Replace Rear Door Primary Struts

Classification Campaign Bulletin **Section/Group** 11 - Closures **Country/Region** United States

Year 2016 **Model** Model X **Version** All

Figure 3

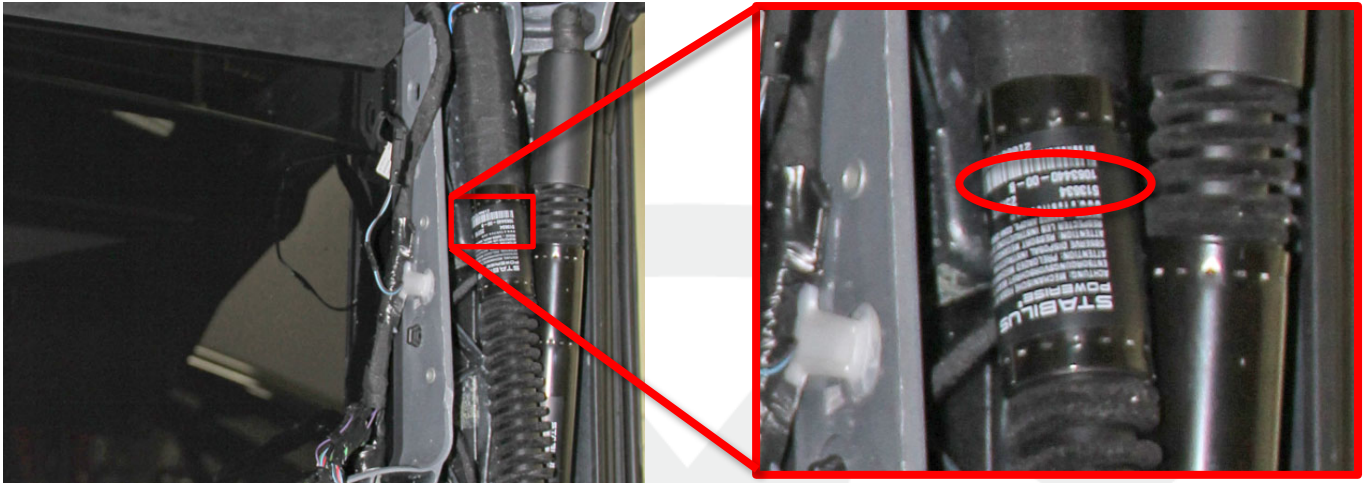
5. Inspect the revision level of the front primary strut (Figure 3):

- If it is revision "C" or later, reinstall the front upper bracket. Continue this procedure.
- If it is revision "B" or earlier, replace the forward primary strut (refer to Service Manual procedure 11331002).
